Gate Burton Energy Park Environmental Statement

Volume 3, Appendix 10-K: Lincolnshire County Council Consultation Meeting Notes
Document Reference: EN010131/APP/3.3
January 2023

Minutes

Meeting name	Subject	Attendees
Gate Burton Solar Farm	Review of additional viewpoints/photomontages suggested by Lincolnshire County Council	OB - Oliver Brown (on behalf of LCC) JS - Joerg Schulze (AECOM) RW - Rupert Wilson (AECOM)
Meeting date	Time	
30.03.2022	2.30pm	
Location	Prepared by	
MS TEAMS	Rupert Wilson, Joerg Schulze

Viewpoint 12: Park Plantation PRow Public Footpath; Knai/44/2

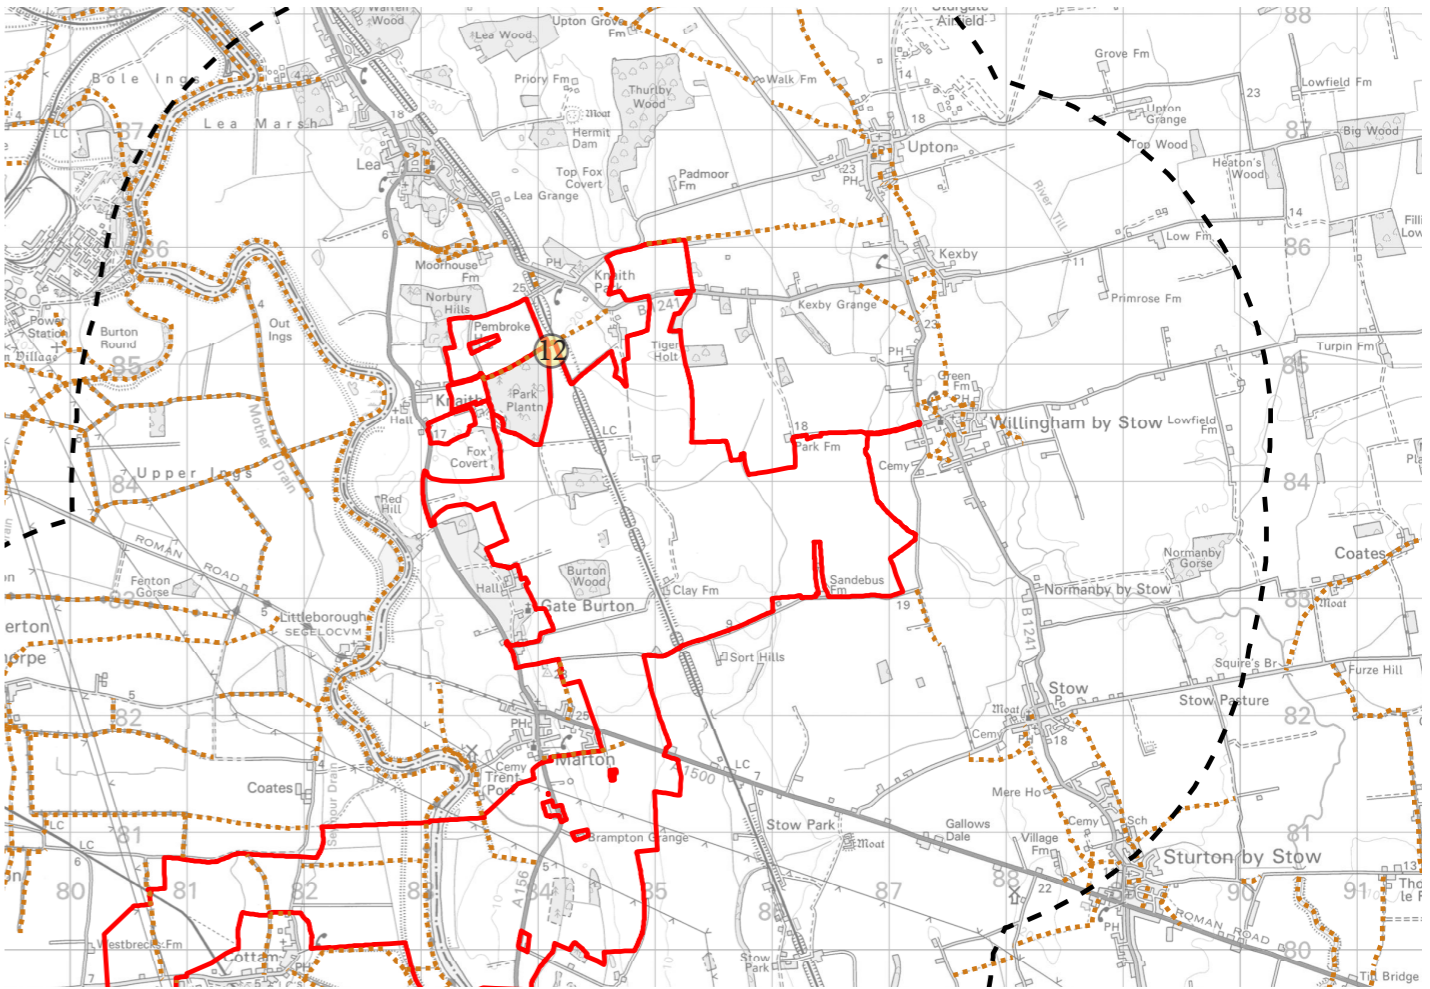
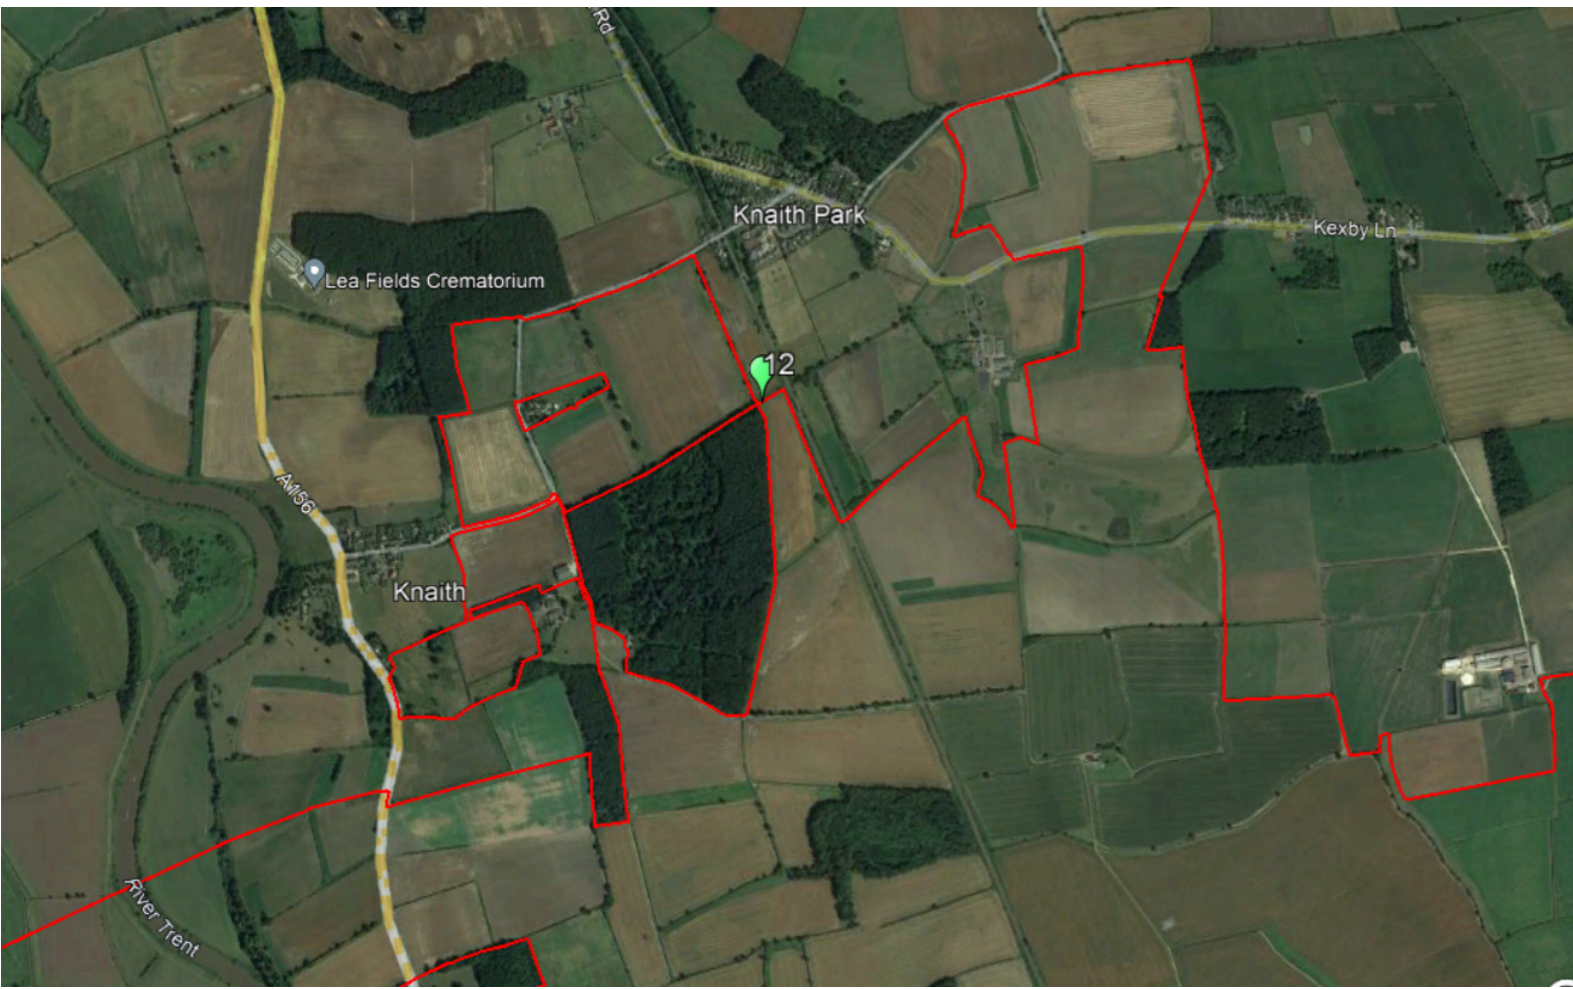
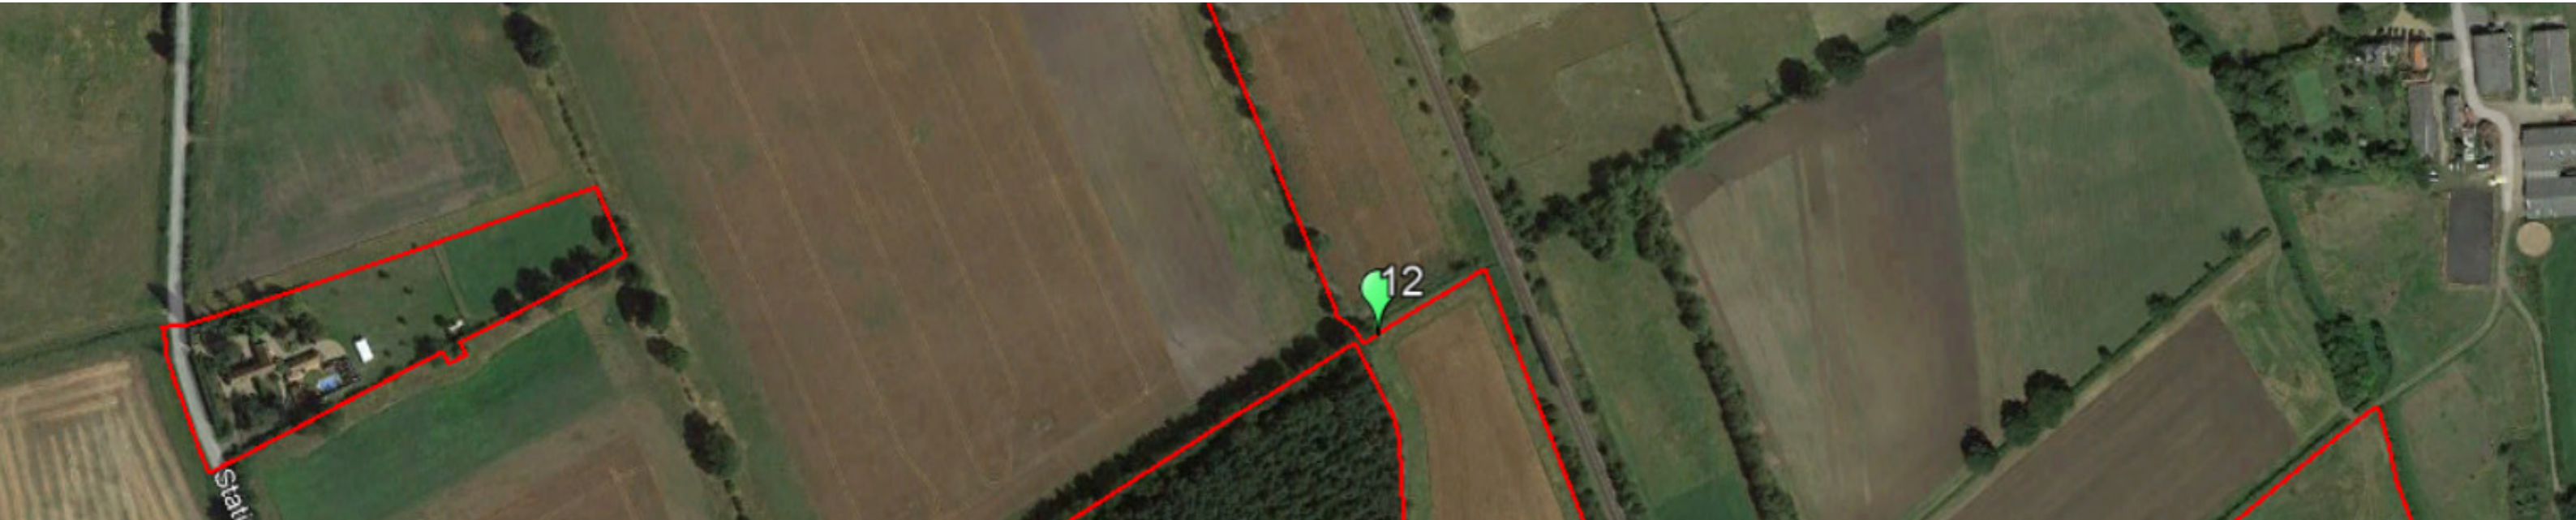
Viewpoint 12 will have a view of the solar farm at this location. No site photography captured.

Photomontage Suggested.

- Viewpoint 11: B1241 - Viewpoint 11 will have a view of the upper elements of the solar park at this viewpoint. Photomontage Suggested. **AGREED**
- Viewpoint 12: Park Plantation PRow Public Footpath; Knai/44/2 - Viewpoint 12 will have a view of the solar farm at this location. No site photography was captured. Photomontage Suggested. **AGREED NOT TO DO A PHOTOMONTAGE DUE TO SAFETY/ACCESSIBILITY ISSUES.**

Viewpoint 13: Marton PRow Public Footpath; Mton/69/1

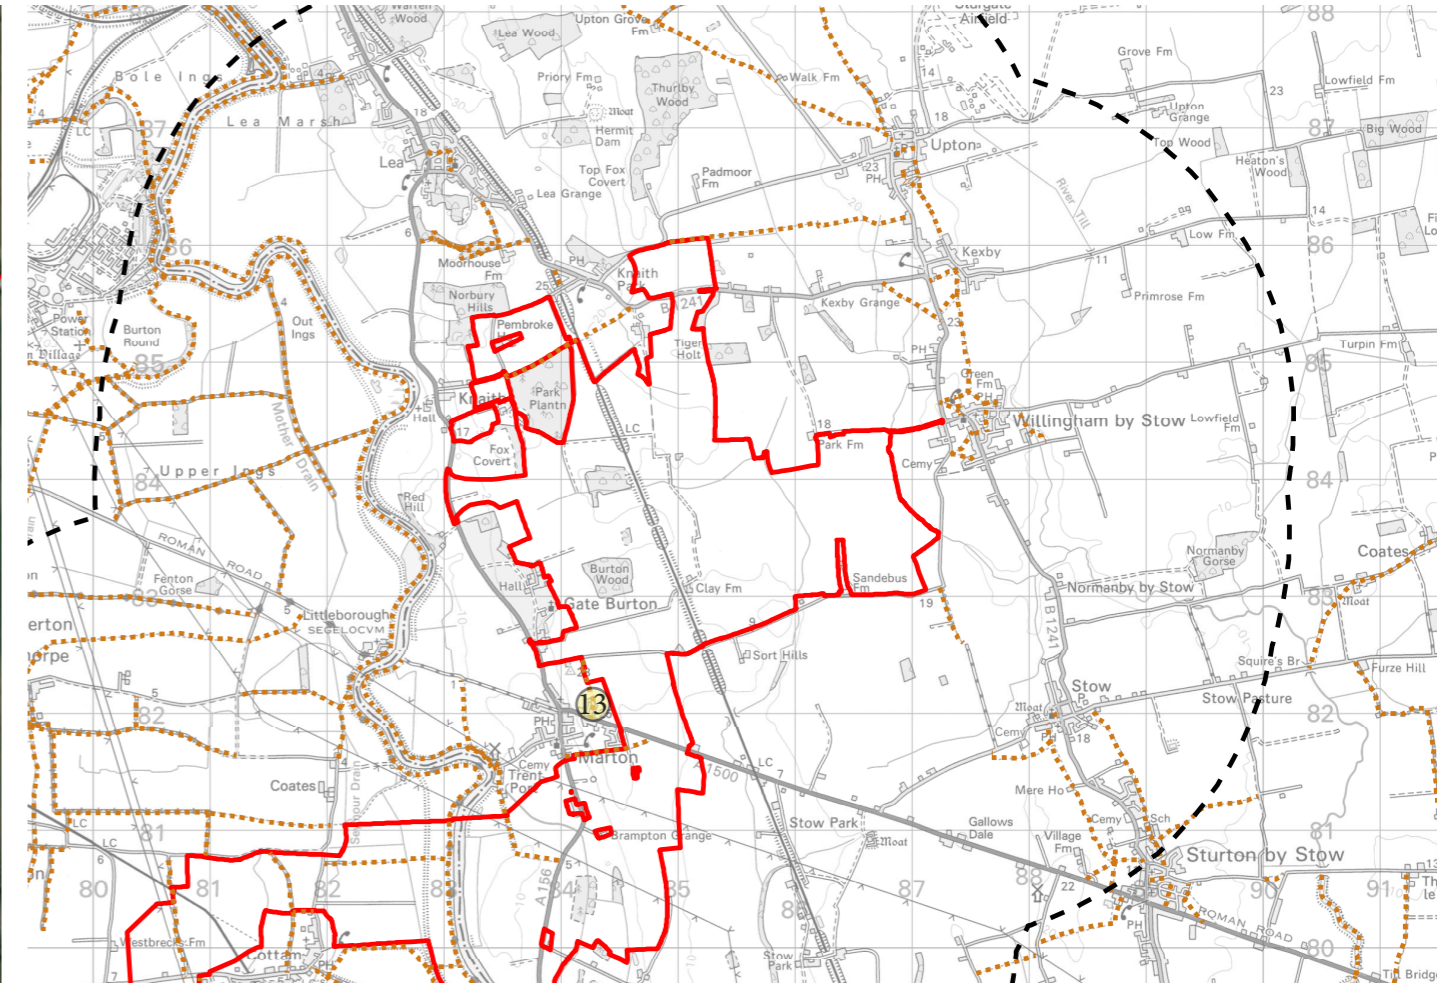
Viewpoint 13 will have a view of the solar park at this viewpoint. **Photomontage Suggested.**

- Viewpoint 13: Marton PRow Public Footpath; Mton/69/1 - Viewpoint 13 will have a view of the solar park at this viewpoint. Photomontage Suggested. **AGREED**

Viewpoint 14: Littleborough Tow Path

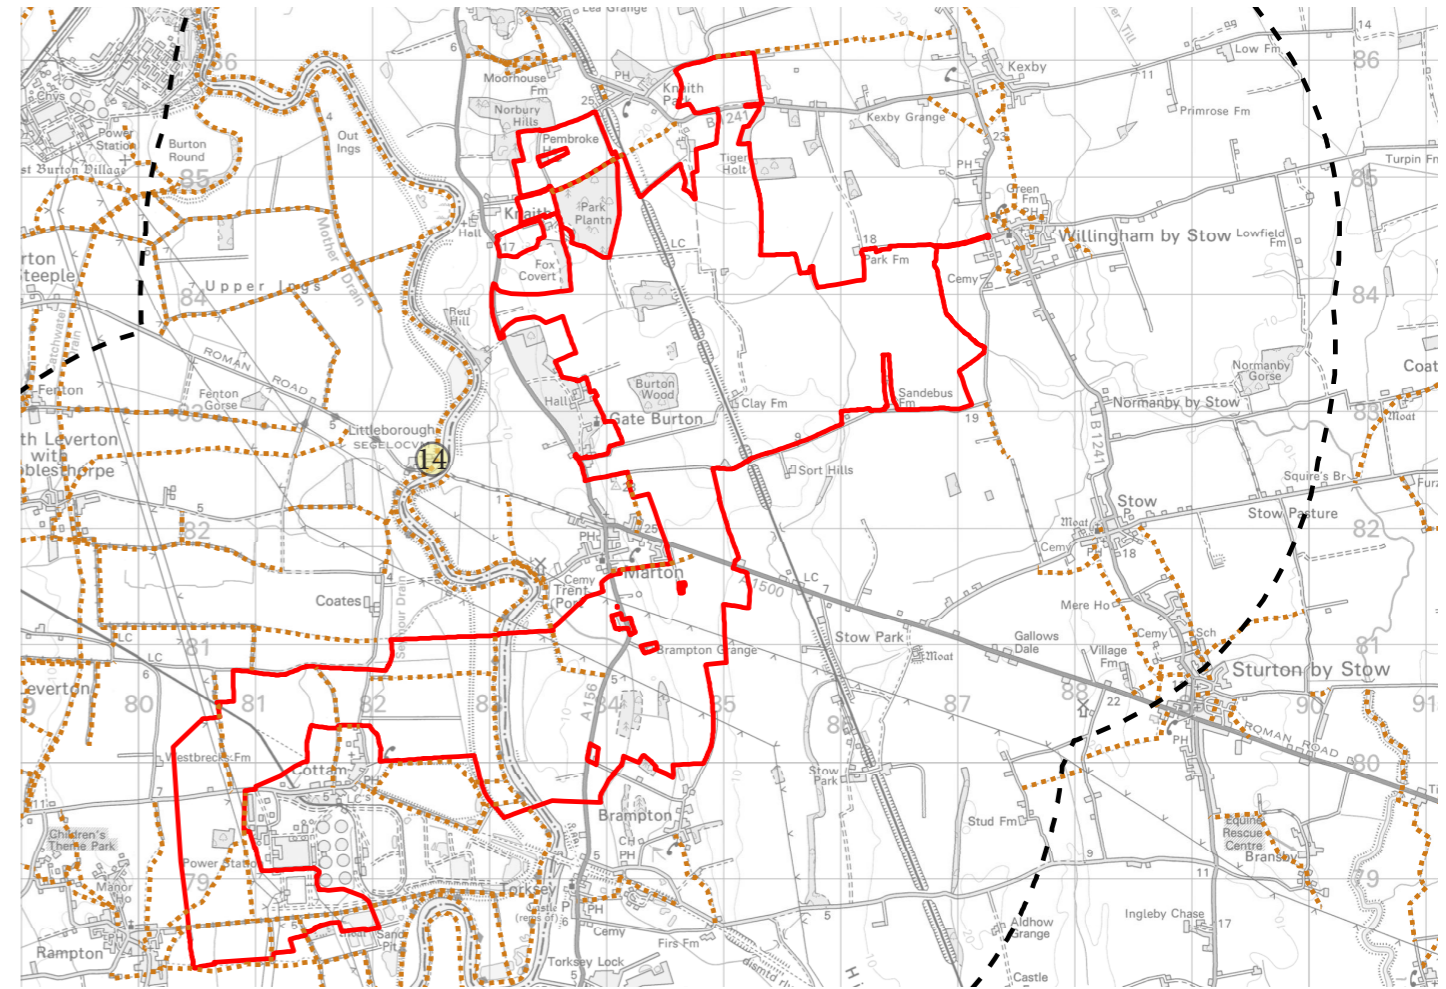
Viewpoint 14 may have a view of the upper elements of the solar park at this viewpoint. **Photomontage Suggested.**

- Viewpoint 14: Littleborough Tow Path - Viewpoint 14 may have a view of the upper elements of the solar park at this viewpoint. Photomontage Suggested. **AGREE**
